Agenda – Standing Policy Committee on Downtown Development, Heritage and Riverbank Management – July 7, 2015

Item No. 1 **Appeal - Variance – 300 Princess Street**
(Point Douglas Ward)
File DAV114337A/2015B

Title: DAV 15-114337/B – 300 Princess Public Hearing

Siloam Mission – Site Plan

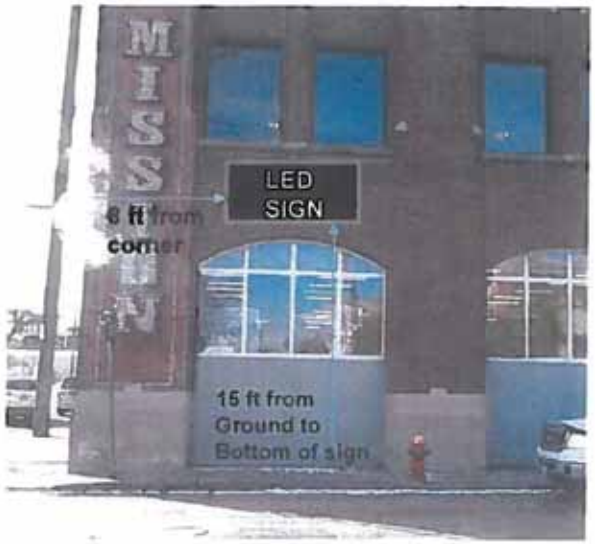
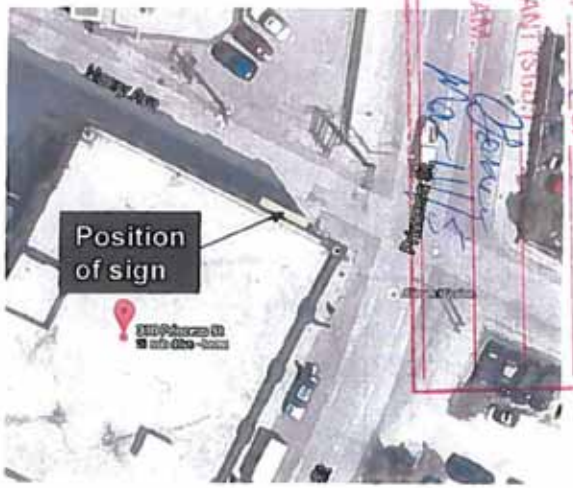
Project Description:
The applicant proposes to erect a digital sign on the northeast corner of their building at 300 Princess Street. The sign would be oriented north towards southbound traffic on Princess Street. Although the sign would be flush-mounted to the building, it would still encroach over the public sidewalk.

The urban design direction for signs in the Downtown is that they be in keeping with the character of the building, architecturally integrated and oriented primarily to pedestrians. As expressed in the applicant's letter of intent, the proposed sign is targeted at and oriented to vehicular traffic traveling south on Princess Street. The proposal appears to put the desire for using the building for advertising its messages above the goals of respecting and celebrating architecture in the downtown.

Because the building is up to the right-of-way, this sign protrudes into the sidewalk right-of-way and would require encroachment approval.

Figure 1: Centennial Concert Hall

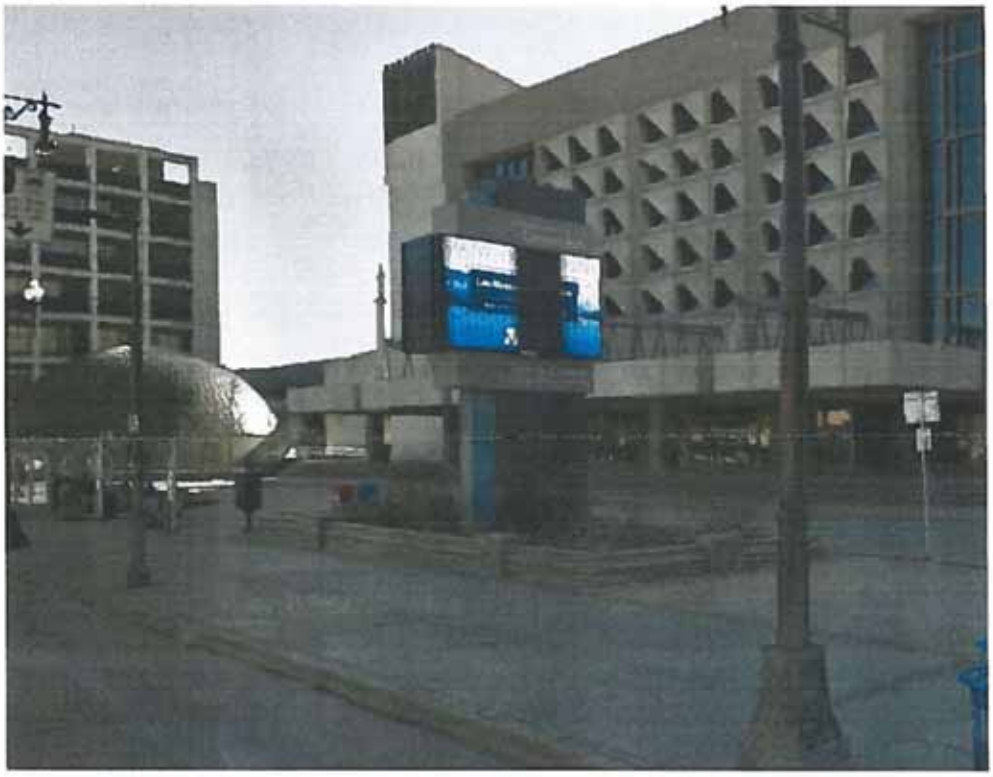
Additionally the sign is compatible with the area when you consider the Centennial Concert Hall **(see Figure 1)** 555 Main St. has a large format LED billboard that not only advertises upcoming events for the Concert Hall but also has 3rd Party advertising. Main Street is designated as an Image Route by the City of Winnipeg.
